1990 - 1991 Corvette: Service Bulletin: Intermittent Electrical Conditions - Repair/Diagnosis Procedures

Subject: INTERMITTENT ELECT. CONDITIONS REPAIR/DIAGNOSIS PROCEDURES

Model and Year: 1990-91 CORVETTE

Bulletin Number: 91-337-6D - (05/30/1991)

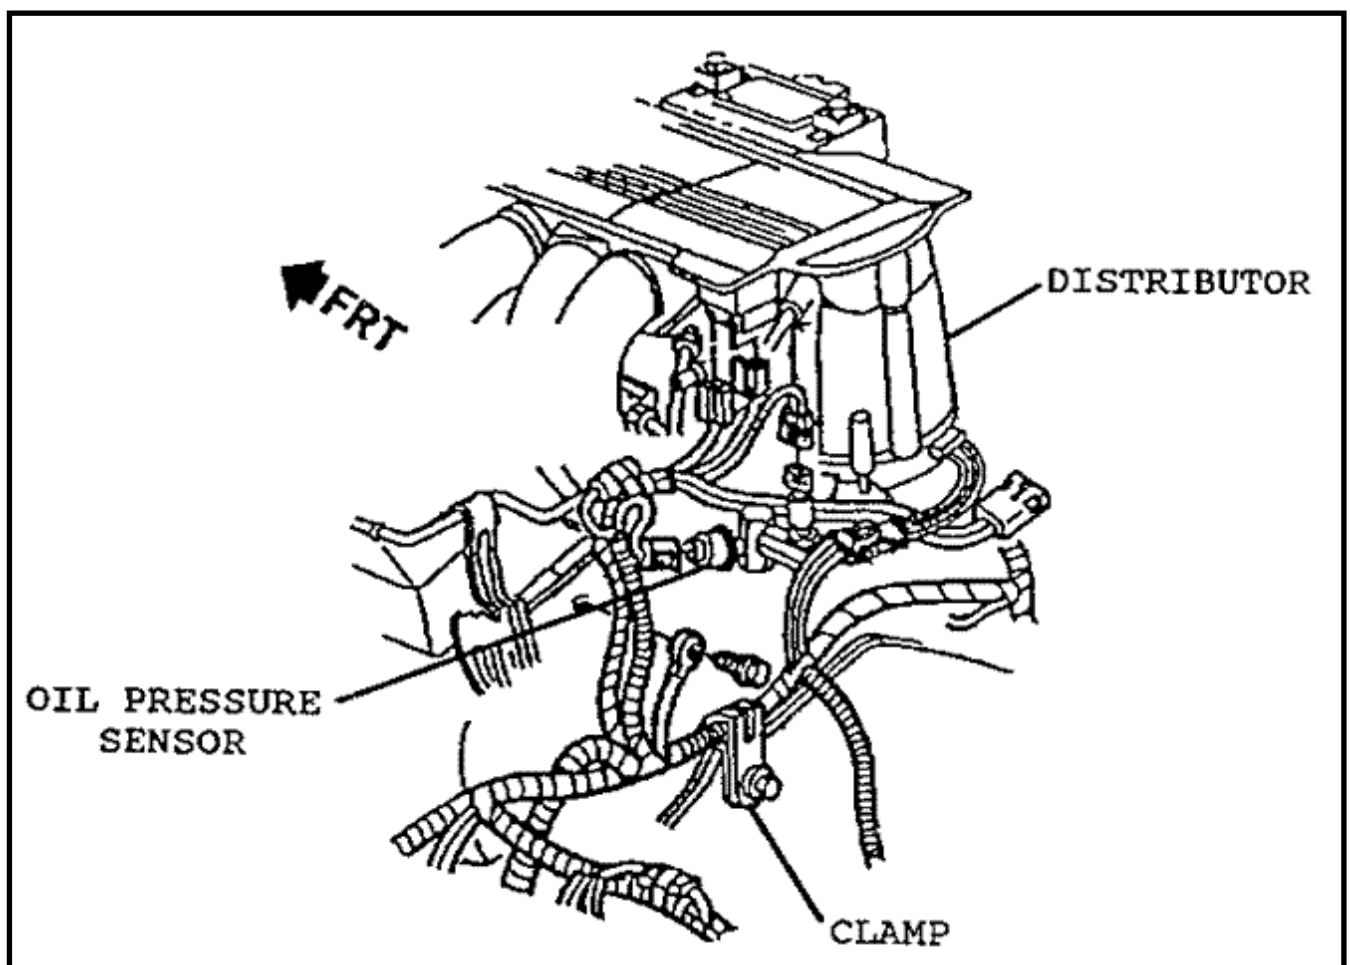
The engine electrical harness may be rubbed thru by the mounting clamp just below the oil pressure sensor (see illustration). The conduit covering the harness may be positioned so that the tab on the clamp can enter the harness thru the slit, allowing the clamp to contact the wires, which are then rubbed thru with the normal movement of the engine.

1. Disconnect negative battery cable.
2. Remove windshield wiper motor.
3. Remove harness from clamp. Carefully inspect the wires for rub thru spots,

and correct the damage as necessary.

4. Wrap the harness with electrical tape. Replace the conduit, then overwrap the outside of the harness with more electrical tape. Secure the harness to the clamp so that the tab cannot enter the harness.
